COMMUNITY PLANNING, DEVELOPMENT & INNOVATION

June 8th, 2022

Re: West End Homes Annexation, Zoning, and Subdivision 1st Sufficiency Review

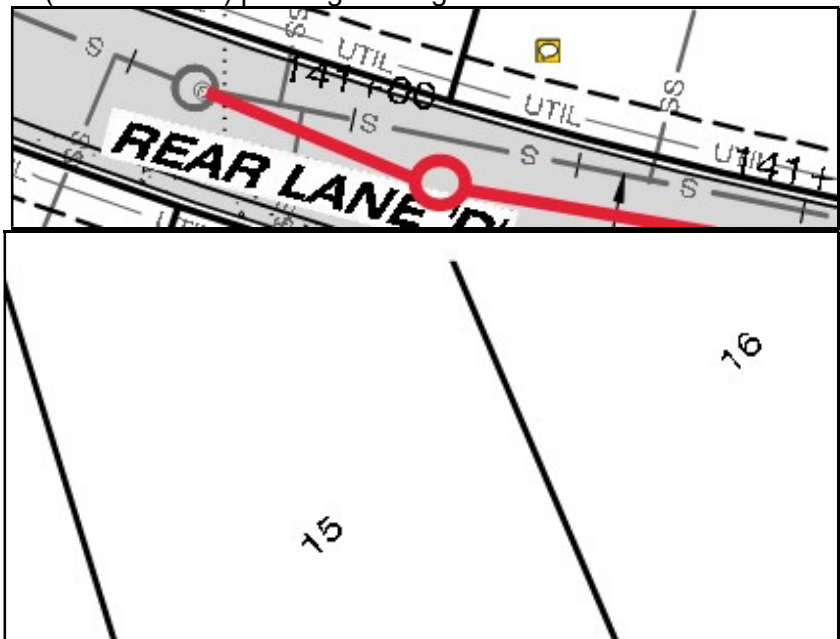
- Sheet 10 – Adjust Sewer Main C alignment and manholes to keep main centered and structures away from cove gutter (shown below) per Engineering.

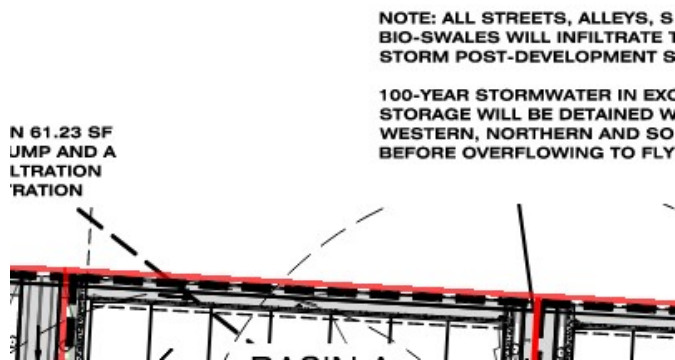
- Drainage Basin Map - How is the composite curve number being calculated for individual lots? The curve number in lots should be based on proposed impervious/impervious area. This could be done with a standard lot layout, pervious/impervious area required by zoning, ect...

- The stormwater report will need to include calculations for how stormwater is routed between subbasins to the ultimate off-site discharge point. Inter-basin routing is required for sub-basins that discharge water from one sub-basin into another. The calculations should include any intermediate flow channels, detention basins or culverts. These calcs are required to support post-development 100-yr discharge rates crossing the site boundary. The attached figure has an illustration of where Engineering anticipates inter-basin flow calculations will be required.
-
